SEWAGE DISPOSAL SYSTEM

A REPAIR

HOWARD COUNTY
BUREAU OF ENVIRONMENTAL HEALTH

SUBDIVISION _____ ROAD 3582 Church Road LOT _____

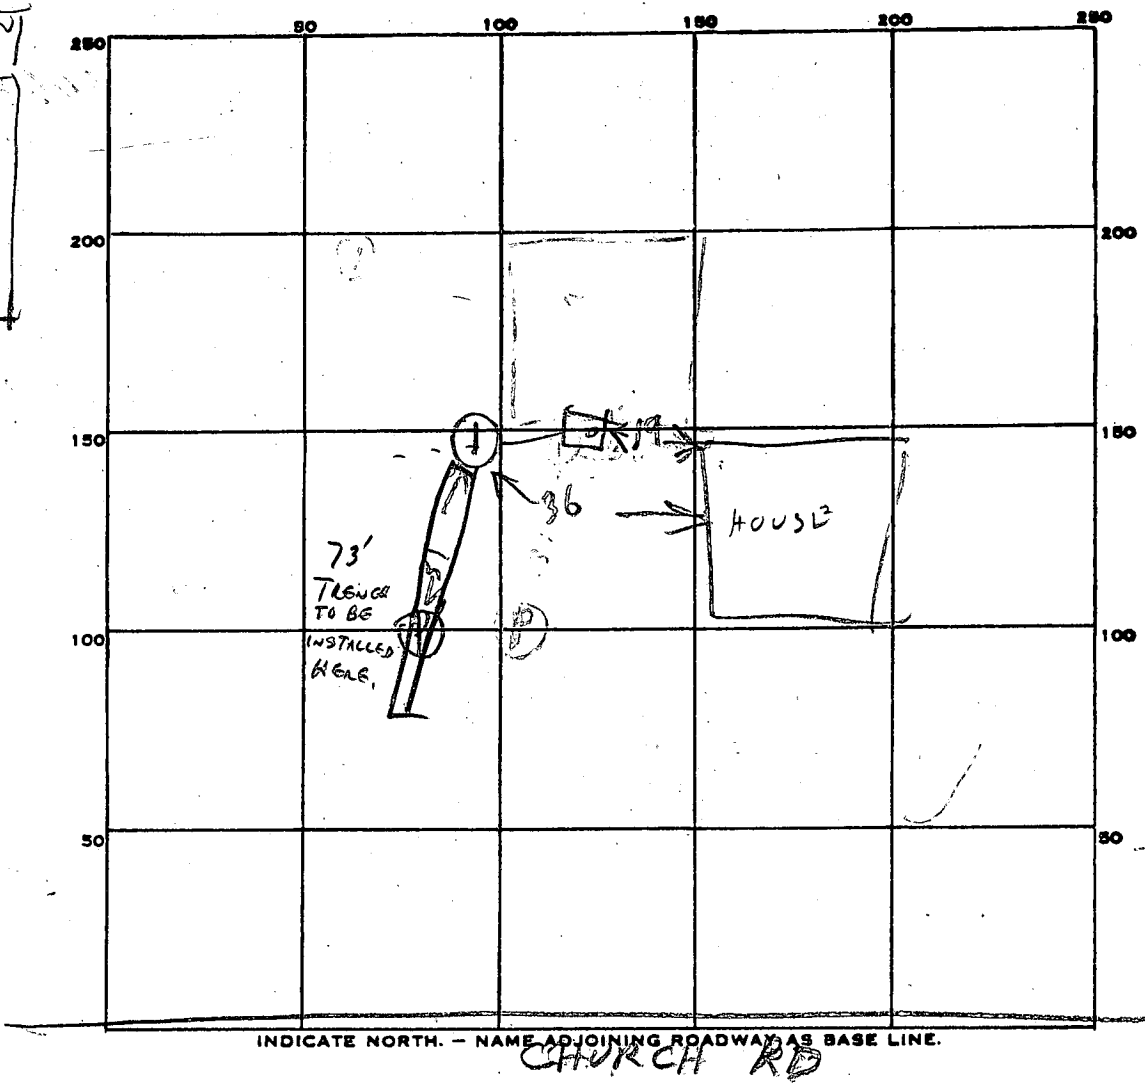
REPAIR - CALL FOR INSPECTION WHEN GROUND IS OPENED UP SO SANITARIAN CAN RECOMMEND REPAIR.

TRENCH - 2 FT WIDE 14 FT DEEP 73 FT LONG
11 FT OF STONE (800 SQ FT SIDE WALL AREA ON ONE
SIDE OF TRENCH) START THE TRENCH AT A POINT
36 FT FROM THE CORNER OF THE HOUSE & 31 FT FROM
THE ELECTRIC POLE. RUN THE TRENCH AWAY FROM
THE HOUSE. RH

REMARKS 3/12/86 - SOIL OK - DECIDED DEEP TRENCH

3/12/86 - TANK IN PLACE. SOIL COLLAPSING, STONE NOT YET AT SITE. OK TO

INSTALL STONE AND COVER WITHOUT INSPECTION - HEAVY RAIN EXPECTED. C. WILLIAMS

3/13/86 SYSTEM INSTALLED WITHOUT INSPECTION. INSTALLED AS INDICATED 73 FT TRENCH WITH 11 FT STONE. C.W.

LOCATION SURVEY

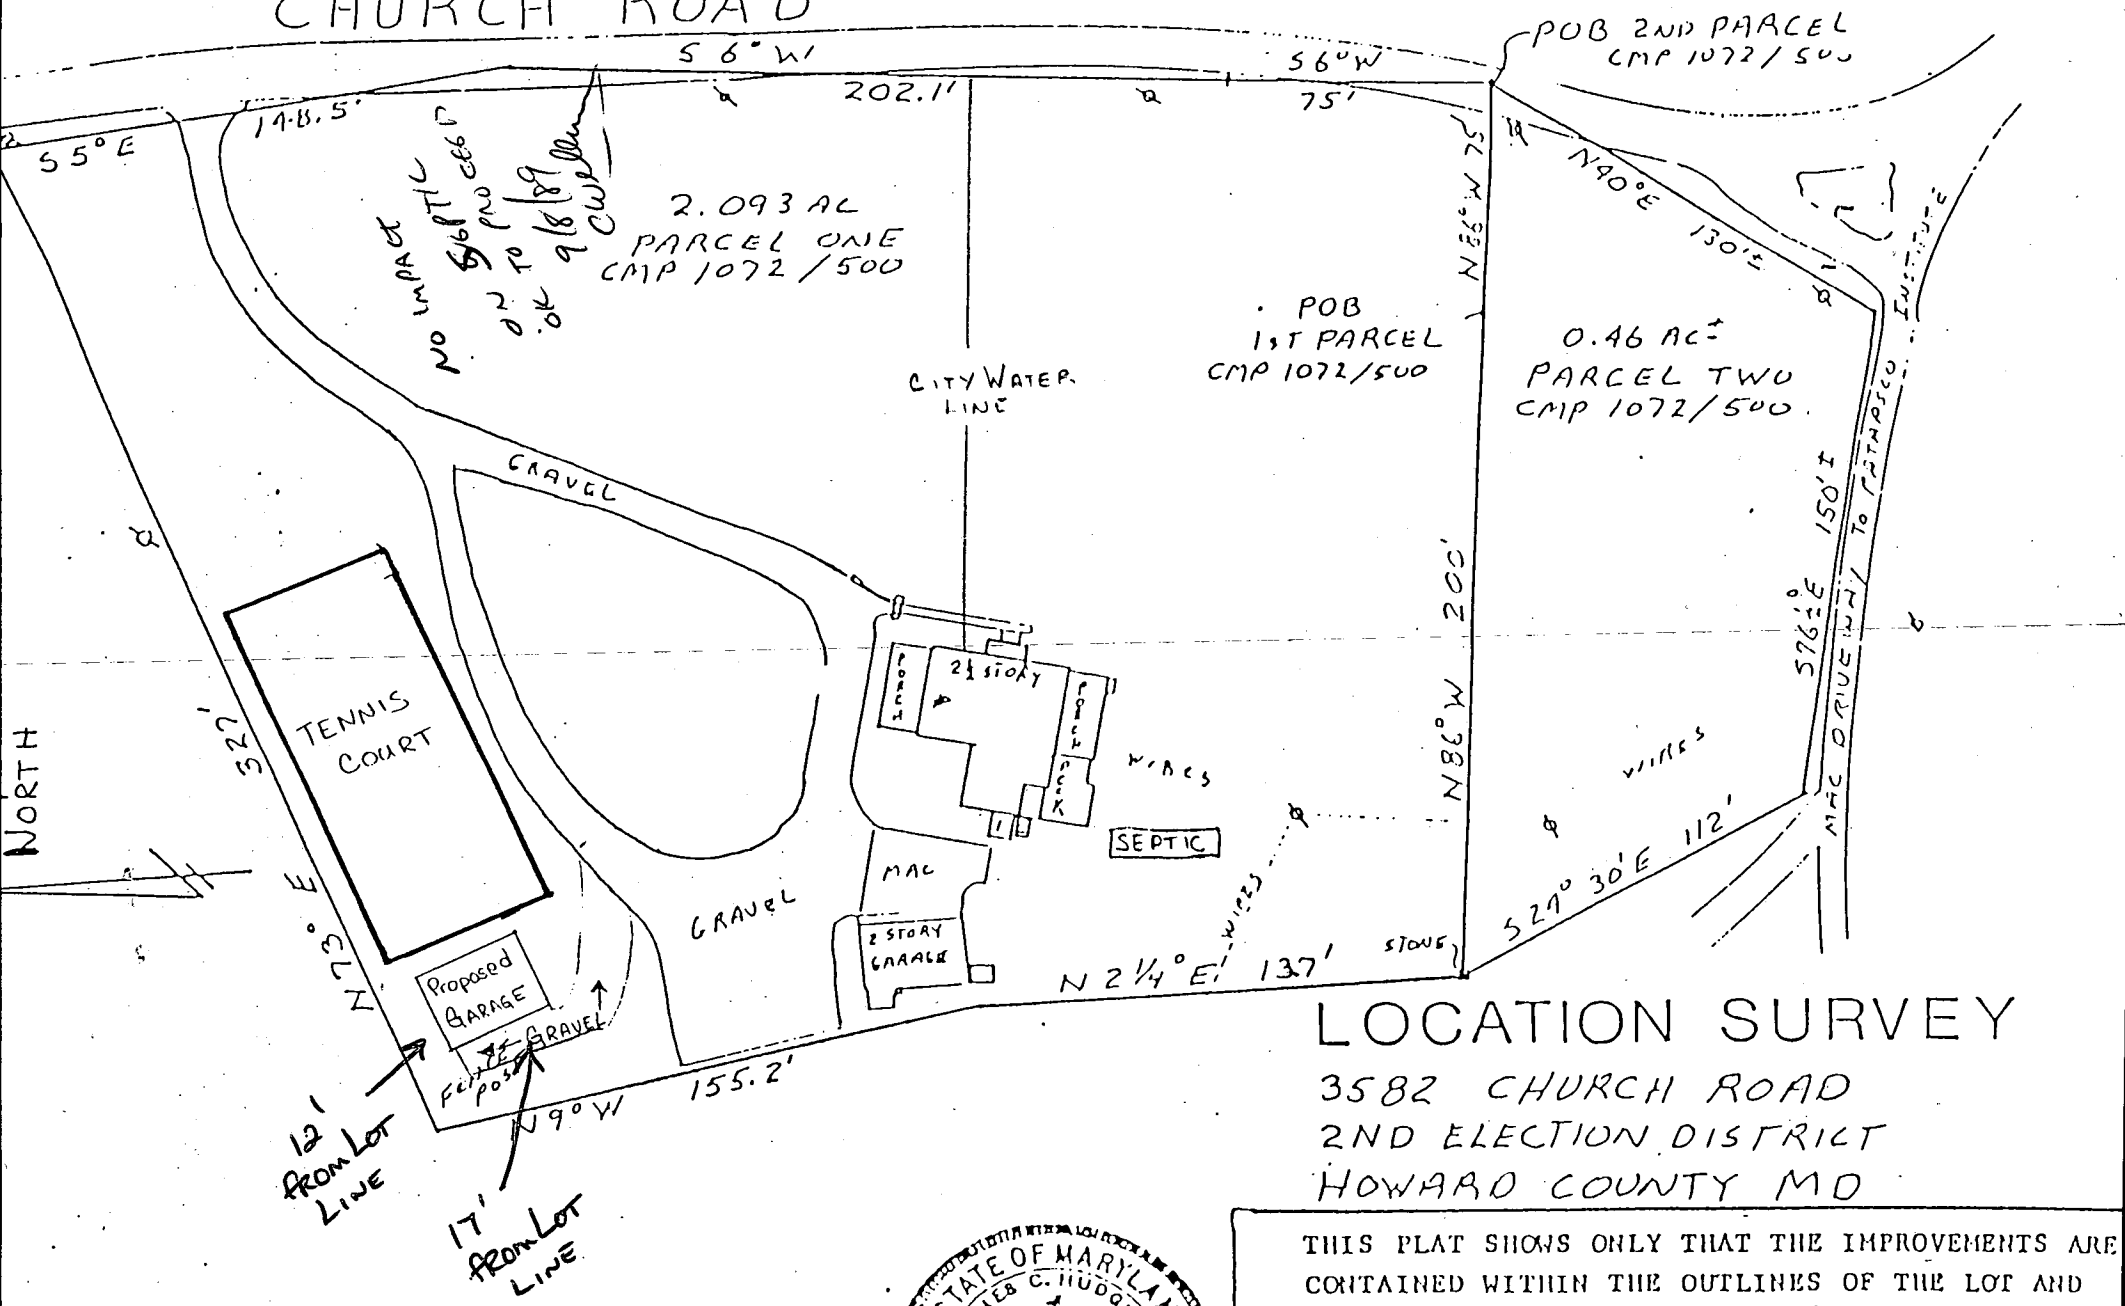
3/13/86 - TANK COVERED & CLEANOUTS OK. BEWARE DOGS RH
